CITY OF WAUPUN
PLAN COMMISSION
MINUTES OF THE JULY 17, 2013MEETING
(**Draft)

Date: July 22, 2013
To: Plan Commission
From: Mary Kay Vogel
RE: Zoning review of site plan at 1049 S. Watertown St.

Re: Site plan review for 913 and 917 Fraser Lane

SITE LAYOUT
(SCALE: 1 = 500)

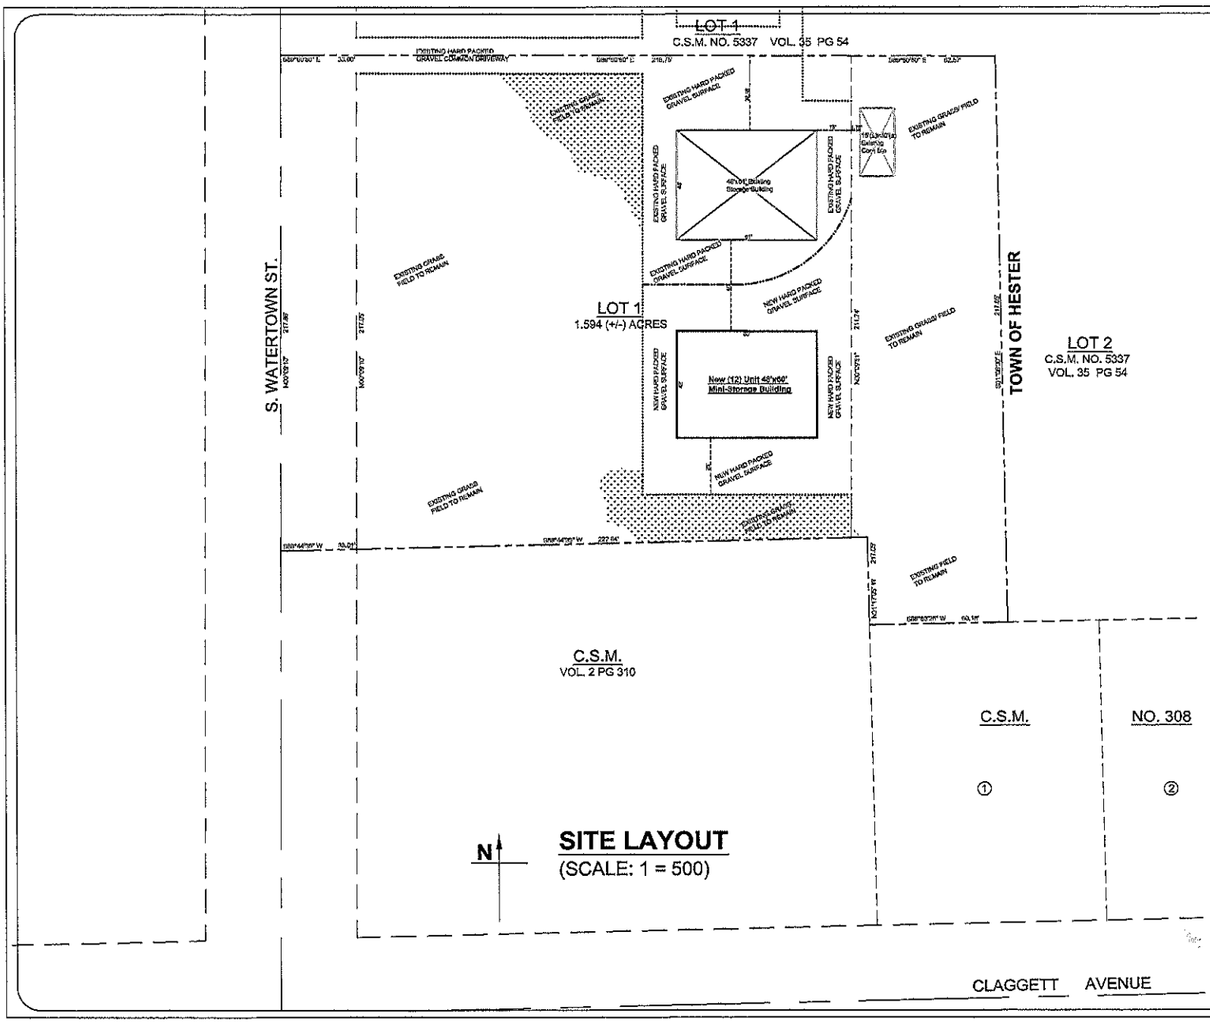
The site plan shows hard packed gravel surface with a 15 foot drive on the East side and a drive on the West side of unknown size. This may be hard for an emergency vehicle to maneuver.

Item	Required	Proposed	Comment
Front yard	15'	15' +	OK
Rear yard	15'	15'	OK
Side yard	15'	25' +	OK

The maximum height allowed in the M-1 District is 65 feet. The proposed structure is shown as 16' 6".

1. Recommendation: Approval, subject to dimensions of drives being approved by the Fire Department.

SITE PLAN

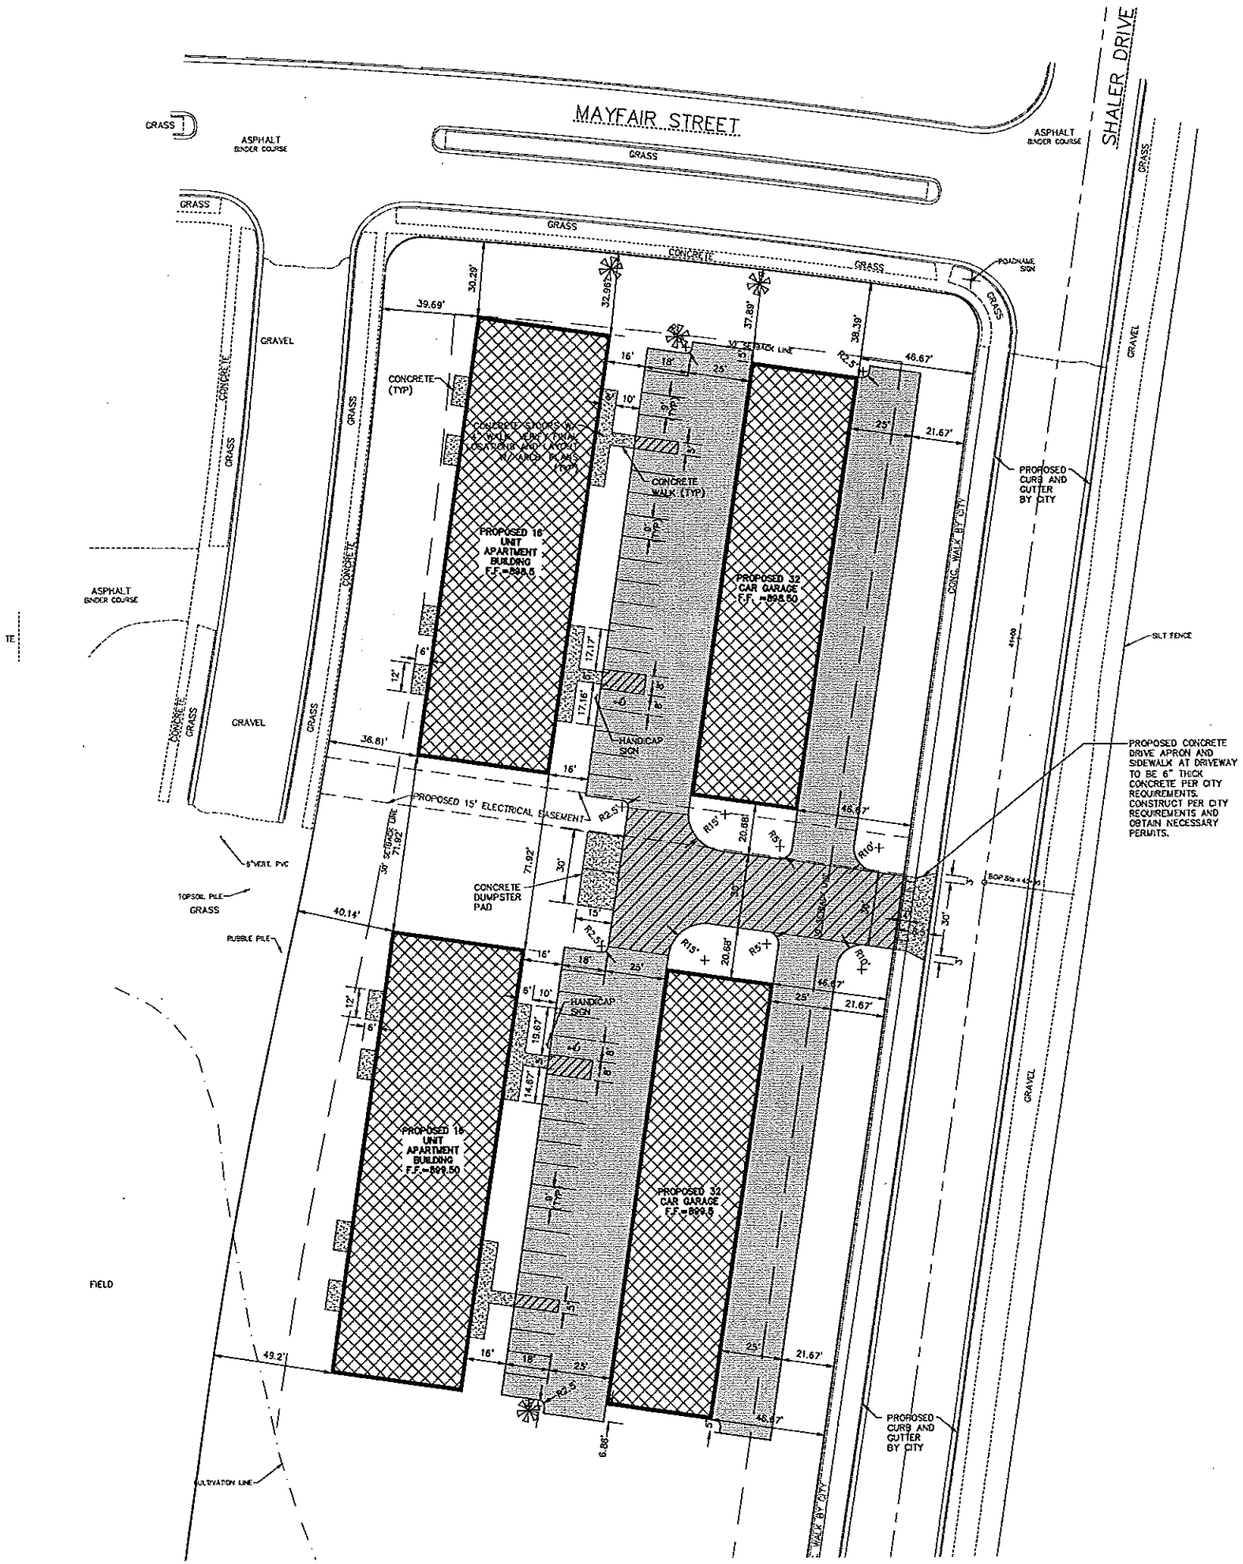
Proposed are two 16 unit multiple family dwellings and two detached accessory parking structures. The Plan Commission has the power to allow more than one principal structure per lot if such public buildings are under the same ownership and the uses are compatible (16.01 (d) (i)).

Parking requirements are two stalls per unit. Sixty-four stalls are required. 101 stalls are proposed, but the size shown is 9' wide by 18' deep. Ten feet by twenty feet is required. If stalls are provided as required by Section 16.11, then the paved areas will increase by 2 foot depth. This would still provide the required setback from Shaler Street to the garages, but would bring the paved area to 18 feet approximately to the lot line.
